**From:** Tift, Rachel  
**Sent:** Friday, August 3, 2018 1:12 PM  
**To:** John Locklear  
**Cc:** Morgan, Steve  
**Subject:** RE: enterprise elevations

PROJECT:  
TOPOGRAPHIC DATA COLLECTION 3/28/18  
ENTERPRISE ROAD CLASS III  
RECYCLING & DISPOSAL FACILITY  
DADE CITY, PASCO COUNTY, FLORIDA

PROFILE

FIGURE NO. 2

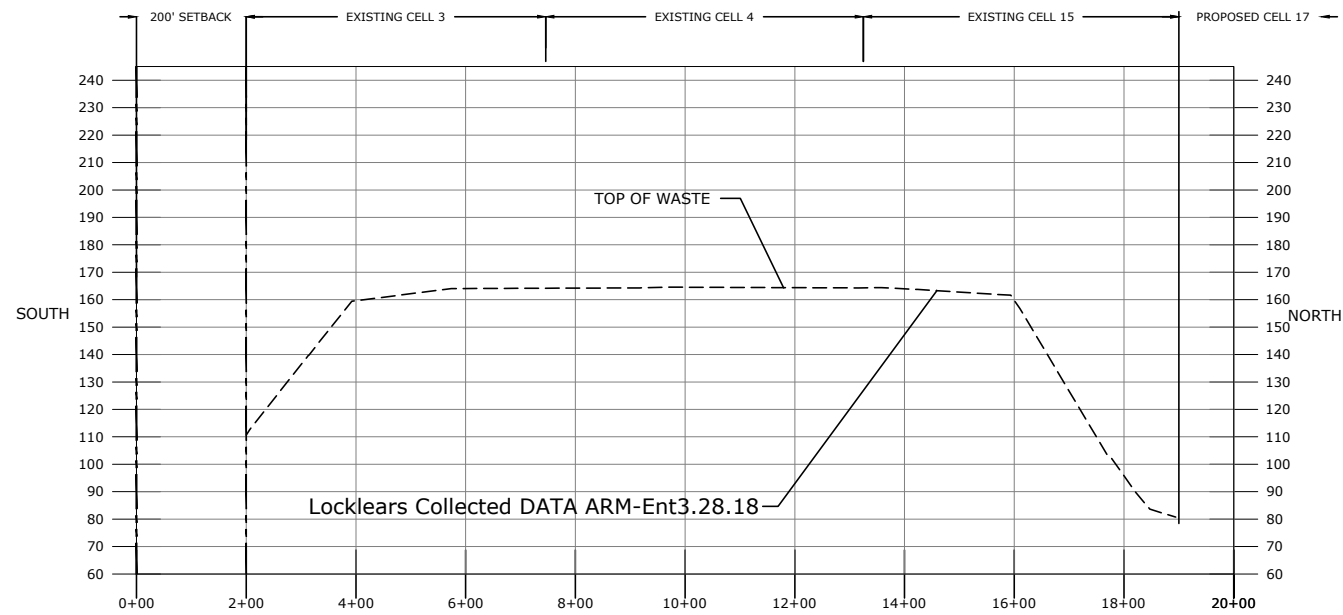
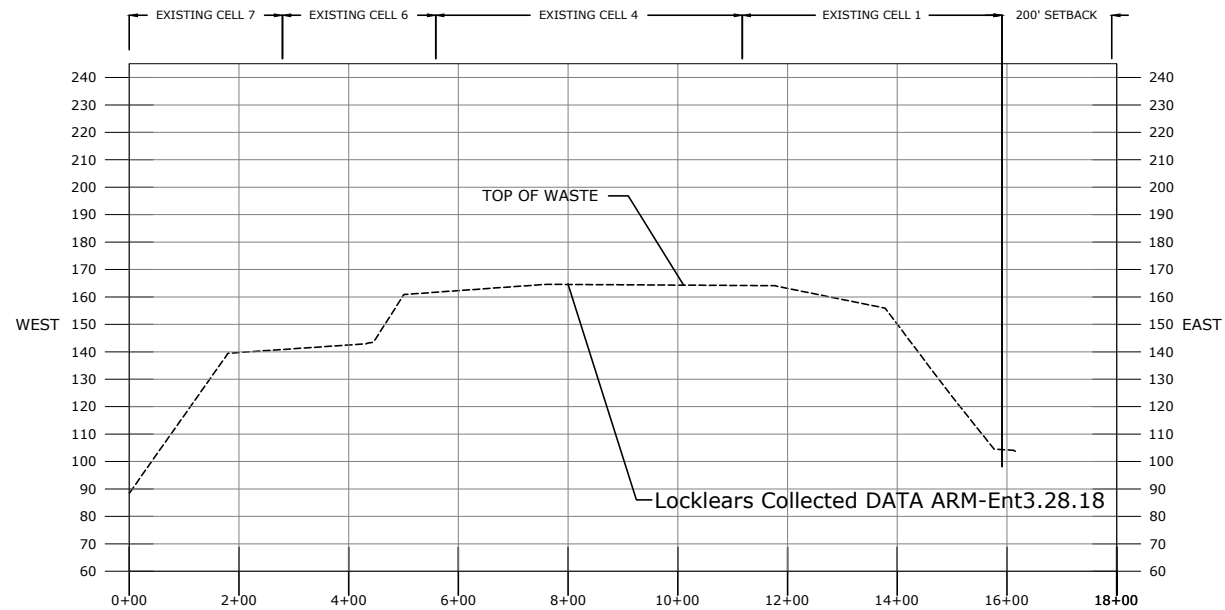
Based on a review of provided drawings, the plan view representation of the topographic contours are not an adequate substitute for a topographic survey prepared by a professional surveyor in accordance with the criteria of Subsection 62-

701.330(3)(c), F.A.C. While the elevation points themselves may be accurate, the contours lines presented do not appear to represent consistent intervals between the lines and are not labeled.

Based on the Department's response below, we need to request an extension in order to do the survey. Therefore, we are requesting a 60 day extension. Please confirm approval. Thank you,
